# IEEE P802.15 Wireless Personal Area Networks

Project	IEEE P802.15 Working Group for Wireless Personal Area Networks (WPANs)	
Title	Spectral mask for FSK	
Date Submitted	[June, 2010	
Source	[James P. K. Gilb] [SiBEAM] [555 N. Mathilda, Suite 100, Sunnyvale, CA 94085]	Voice: [408-245-3120] Fax: [408-245-3120] E-mail: [last name at ieee dot org]
Re:	[d1P802-15-4g_Draft_Standard.pdf]	
Abstract	[This document describes changes to add an FSK mask to the draft.]	
Purpose	[To resolve comments in LB51.]	
Notice	This document has been prepared to assist the IEEE P802.15. It is offered as a basis for discussion and is not binding on the contributing individual(s) or organization(s). The material in this document is subject to change in form and content after further study. The contributor(s) reserve(s) the right to add, amend or withdraw material contained herein.	
Release	The contributor acknowledges and accepts that this contribution becomes the property of IEEE and may be made publicly available by P802.15.

# 2. Suggested text for 802.15.4g

#### 2.1 Comment resolution items for FSK/GFSK

Figure 2—2-FSK modulation

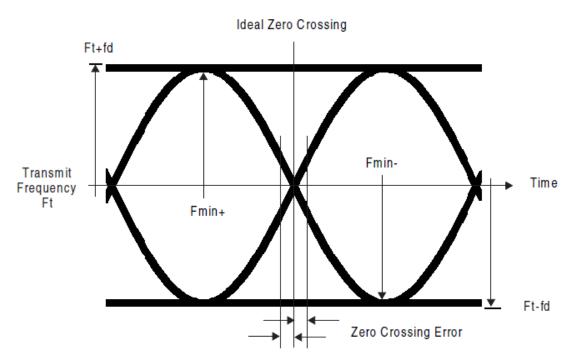
The symbols and terms for 2-FSK signal is illustrated in Figure 2.

For 2-FSK, the error in the modulation,  $\Delta fd$ , at mid-symbol time shall be less than

- ±0.2\* $\Delta$ f for modulation indexes less than or equal to 0.5,
- $\pm 0.3*\Delta f$  for modulation indexes greater than 0.5,

where  $\Delta f$  is defined in 6.12a.1.2.

The zero crossing error shall be less than  $\pm 1/8$  of a symbol period.

Figure 3—4-FSK modulation

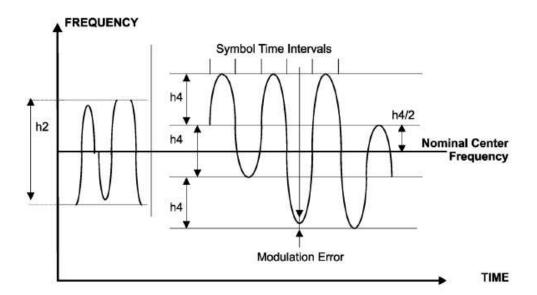
The symbols and terms for 4-FSK are illustrated in Figure 3.

For 4-FSK, the error in the modulation at mid-symbol time shall be less than  $\pm 0.2*\Delta f$ , where  $\Delta f$  is defined in 6.12a.1.2.
